Champaign Park District

ADDENDUM NUMBER 1
TO THE BID DOCUMENT
Operations Shop Backlot Reconstruction
Amendment Date: November 18th, 2026

Impacted
Fencing
Champaign Park
District Operations &...
Contract

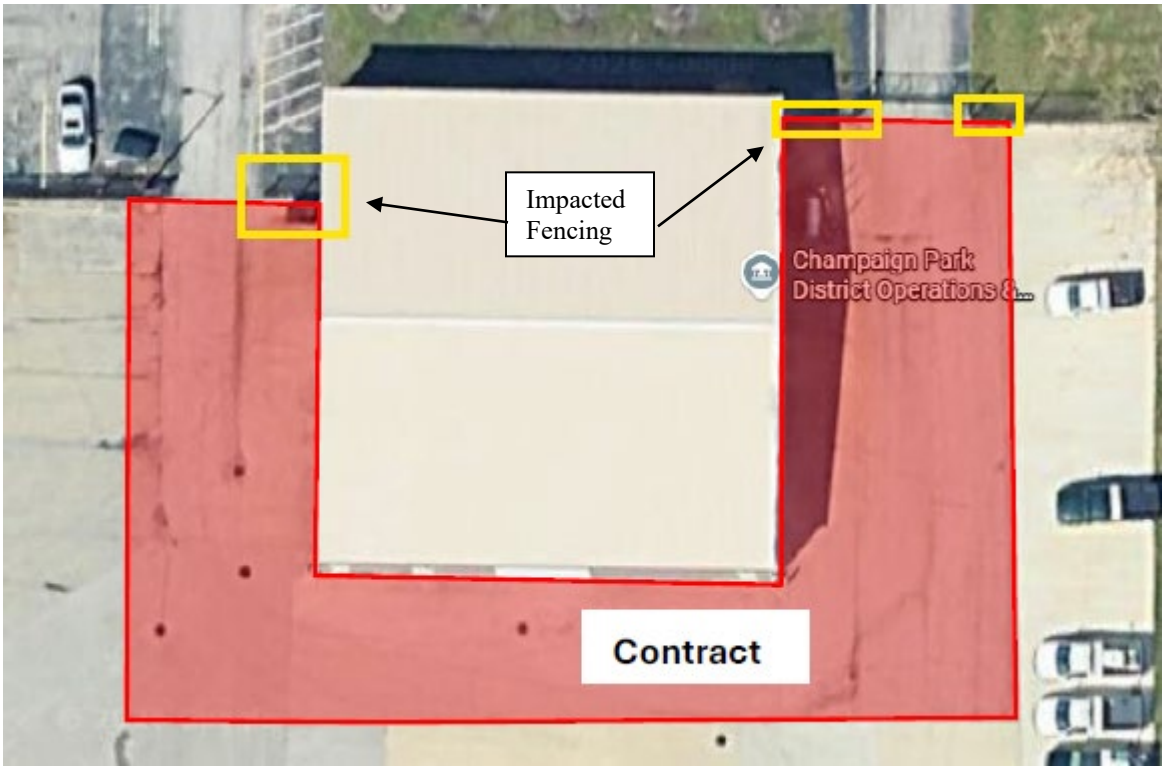
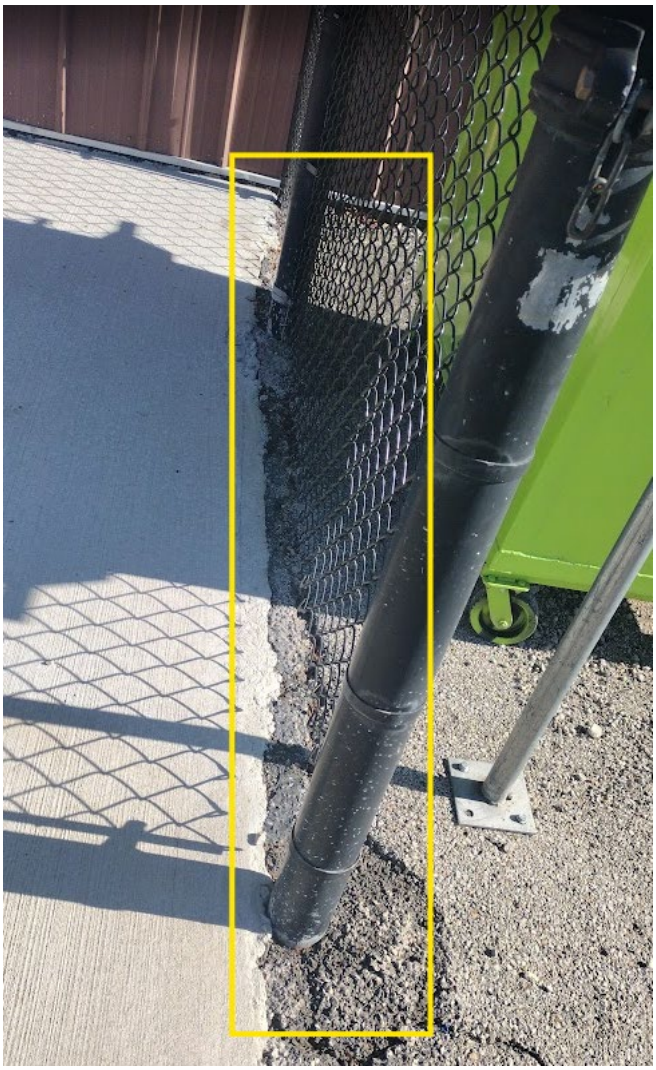
a. *Clarification:* intent is to replace any existing fencing bases within the pavement scope parameters with new concrete base to tie into the new pavement. All impacted existing fencing to be restored to match existing. See attached photos for impacted locations.
